**DESIGN REVIEW BOARD AGENDA
NOTICE OF MEETING**

| TITLE: <p style="text-align: center;"> DESIGN REVIEW FILE: PLAN-2019-30-APRIL-6a 80 GRAFTON STREET (PID #340265) OWNER: 1867 DEVELOPMENTS INC APPLICANT: BILL CHANDLER </p> | |  CHARLOTTETOWN |

| TITLE: DESIGN REVIEW FILE: DESIGN-2019-30-APRIL-6B 4 A PRINCE STREET OWNER: PEI HOUSING CORPORATION | |  CHARLOTTETOWN |

Project
GRAFTON ST PROPOSAL
 Sheet Title
ELEVATION

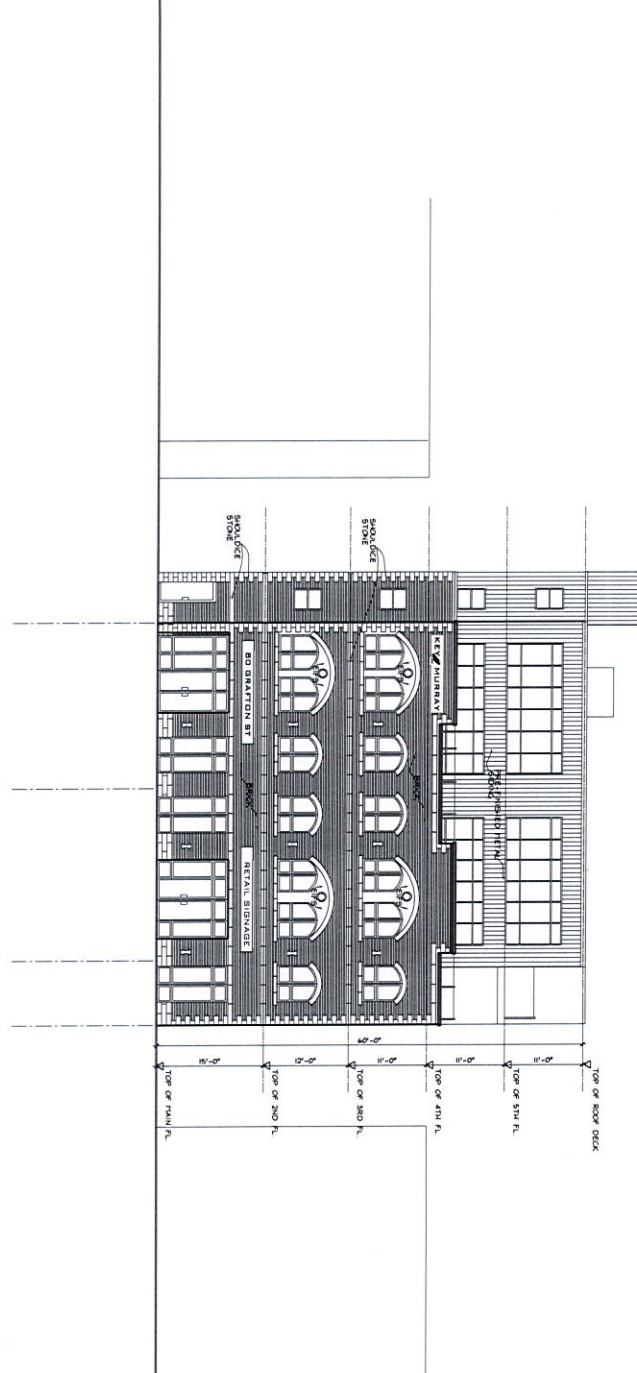
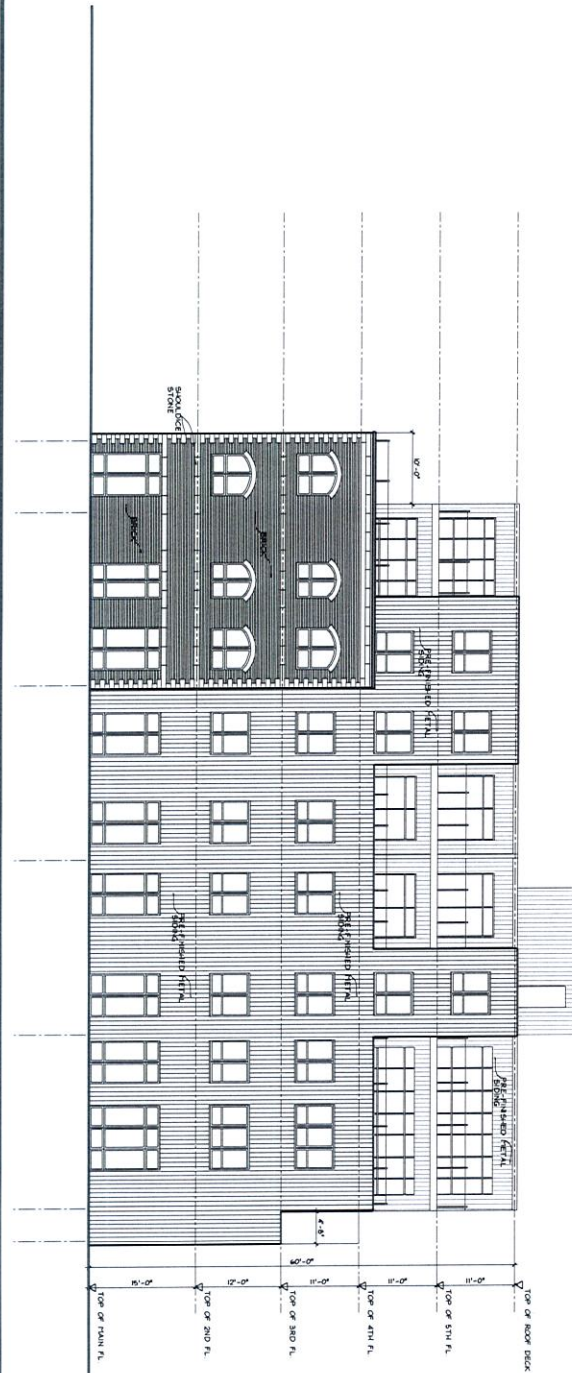
The strong contrasting colour scheme of the shouldice stone and windows de-emphasizes the solidity associated with masonry construction. The window proportions do not reflect load bearing masonry walls. They are too wide and not tall enough. The stucco infill between the windows, is inappropriate. Typically in paired arch-topped windows, there is the masonry opening, and then contained within, is a pair of wood mullied windows. The material and colour located in the masonry opening is consistent.

Project: **GRAFTON ST PROPOSAL**
 Scale: 1/8" = 1'-0"
 Date: FEB. 03, 2004
 Sheet Title: **ELEVATION**
 Dwg. No.: -

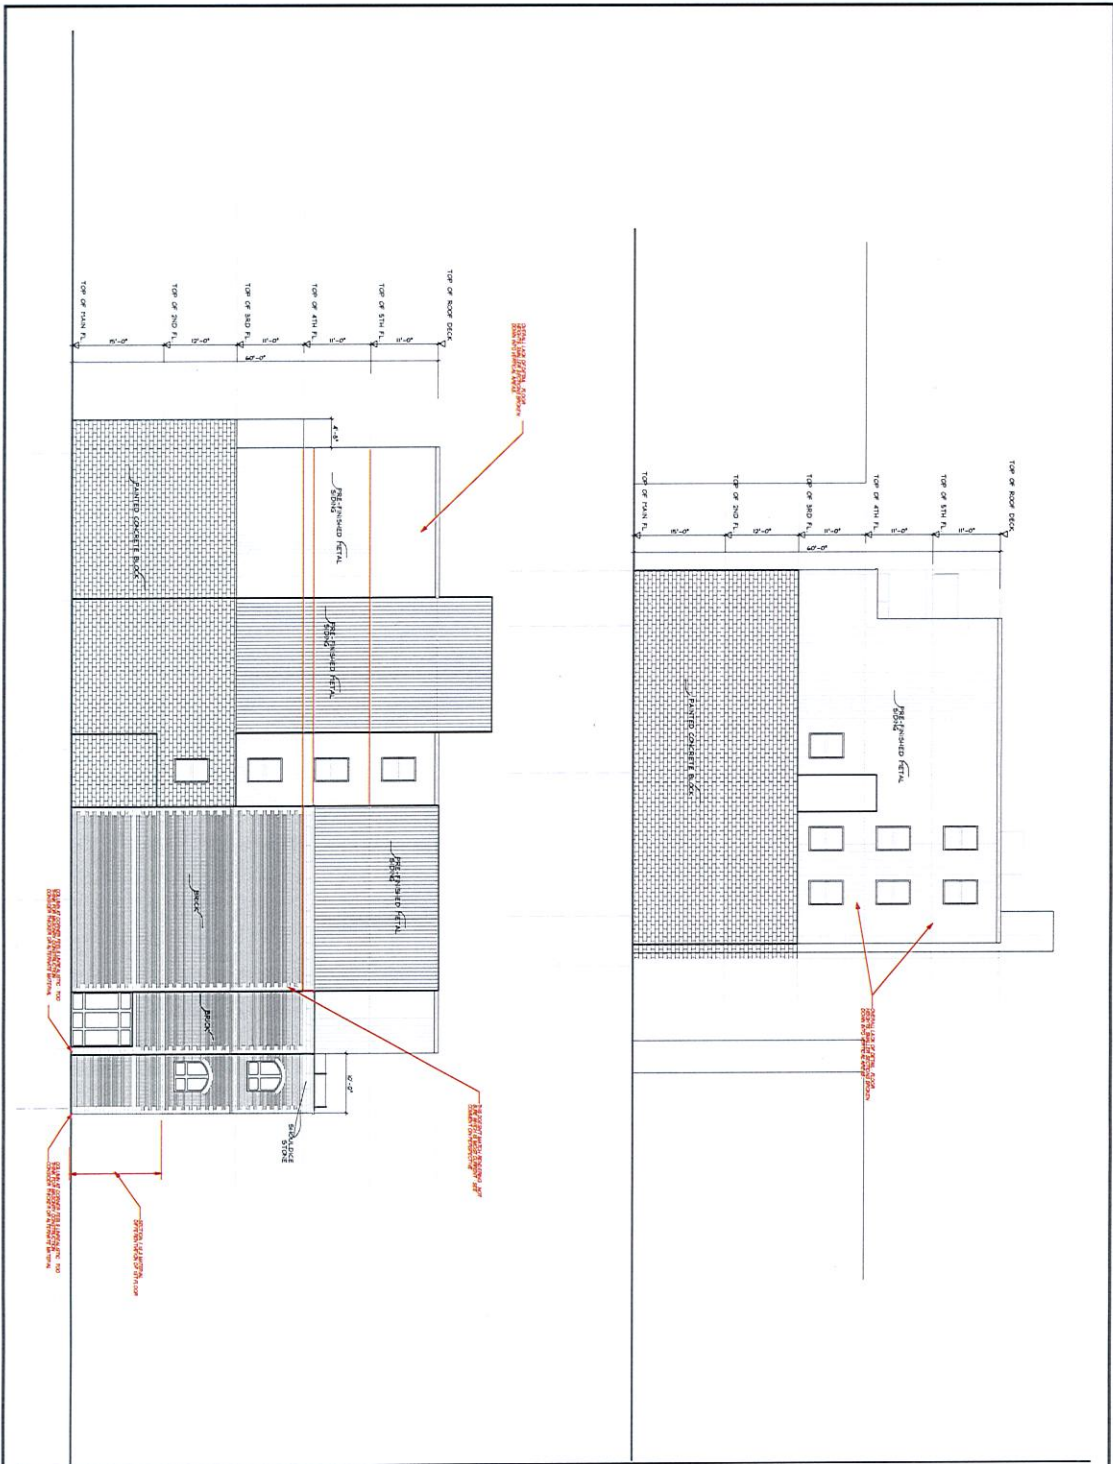
| Section 7.5 Windows | All Sections | The proportion and detailing of the windows are not well aligned with the style of the building. Arch top windows – the mainstyle on the primary façade are not continued on the step-backed portion of the street façade (A8 Elevation) |

PROJECT TYPE
EXTERIOR ELEVATION

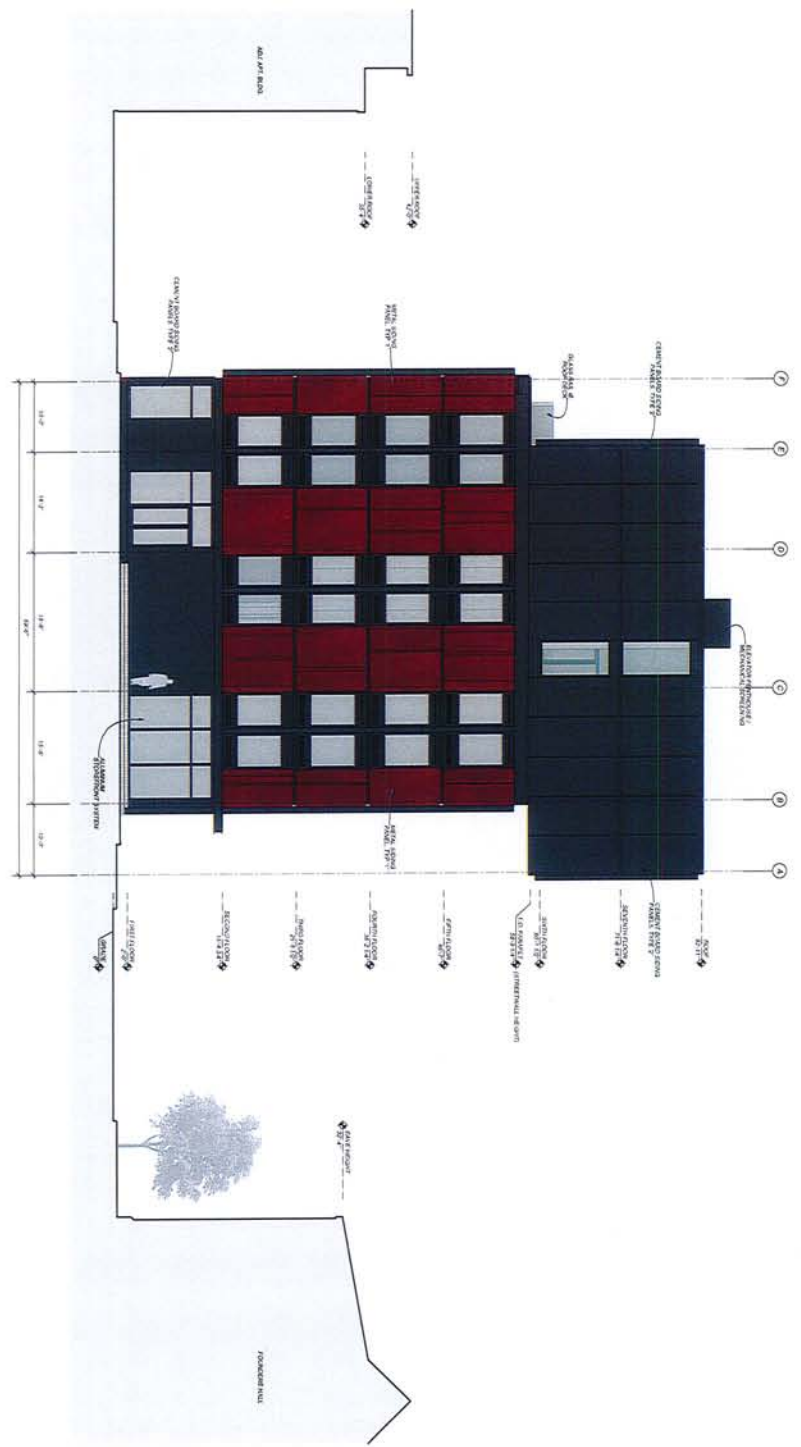
- 7.4 The proposed materials are all acceptable and are true to their nature. We might suggest that at grade level the black cement board could be replaced with black brick which might better relate to both neighbours. This could include the planters as well.

would be to change the grade level cladding from cement panels to black brick. The addition of some nominal masonry would be a design nod to the two neighbours that are predominantly clay masonry. The choice of a black brick eliminates any suggestion of "historic mimicry". Some landscape features like the planters could also be in this dark material.
